Answers to the Questions from the SPSC Referees to the NA62 2012 Status Report

NA62 Collaboration, 02/04/2012

Figure 1: LAV: Data vs. Monte Carlo comparison for the Time over Threshold response as a function of input charge.

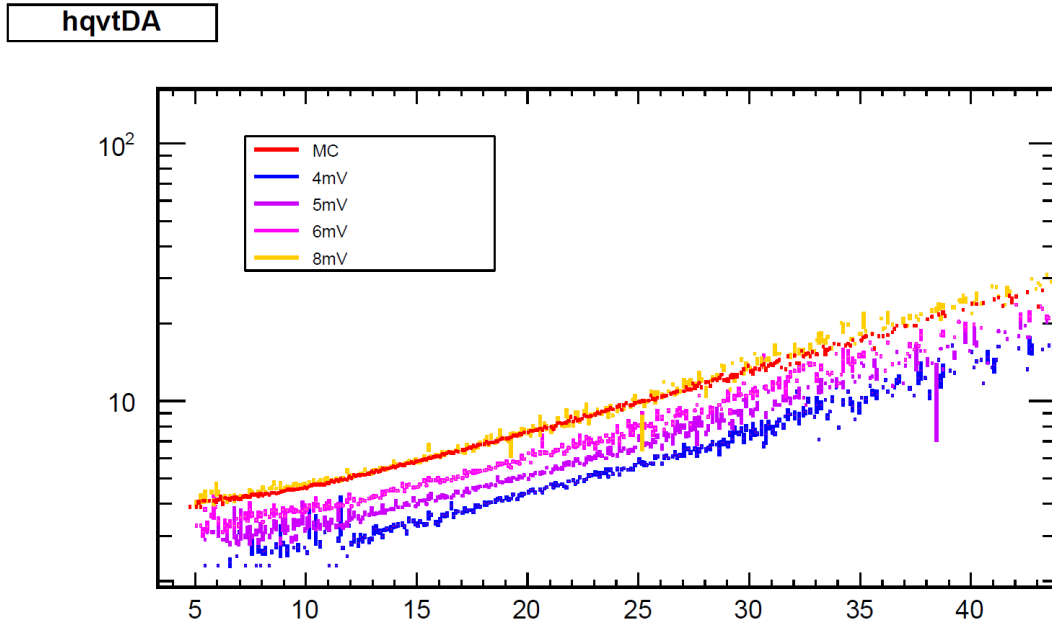
15. *In section 12, Figure 17. I am not quite sure what to make of the comparison of the MC with data: at low ToT, 10-20 ns, the MC matches the 8 mV data well. They start to deviate at around 26 ns and then around 40 ns, the MC matches the 6 mV data. Then at around 50 ns, the MC is again in agreement with the 8 mV data. The MC may also agree with the 6 mV data, but I can not really tell. It seems that the 8 mV data has some strange behaviour.*

Thank you for pointing this out. The MC simulation used to generate the plot presented in the status report was not the most complete one, the PMT capacity was wrong and some resistors were not taken into account. The correct plot is presented in Fig. 1: in this version the agreement is good.
